Statement: To explain the discrepancy
represented on the enclosed
sketched in red ink, and
in black ink,

File 26
Concho County

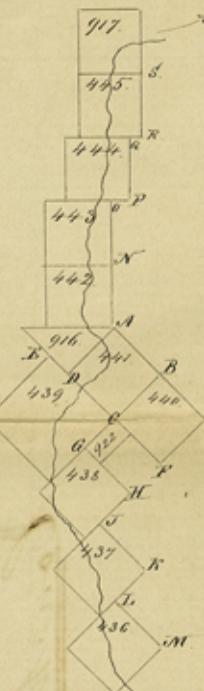
According to the map and the calls in the
fieldnotes of surveys N^os 439, 440 & 441. the square
mile covered on the sketch, in black ink, by
survey N^o 439 appeared vacant. Before I ascer-
tained the error on the ground I surveyed the
land for another claim in reality covered
on the ground by survey N^o 439.

1. for sur. No 439. Beginning 820 vs. N. 45° E. of N. corner of No 438, being corner C. with the bearings correctly described. Thence N. 45 W. etc.
2. of sur. No 440. Beginning at the N. corner of survey No 439. Thence N 45° E - This description is wrong, it begins on the E. corner of survey No 439. Thence N. 45 E. to corner B. correctly described in the same fieldnotes.
3. sur. No 441. Beginning at the W. corner of No 440. Thence N 45° E. 1343 to corner B. correct in the description and on the ground.

F stake } calls for a misq. 7 S 74 E 9 $\frac{1}{2}$ is not to be found on the ground.
 } mds. evidently a mistake. The same description appears for corner B above.

By comparing the description of the fieldnotes on record with the work on the ground and the corners truly established. I find one correction throughout necessary;

"The Survey No 440. 320 ac. W^m Gowin said has to begin on the East corner of survey No 439. in stead of beginning at the N. corner of said Survey."
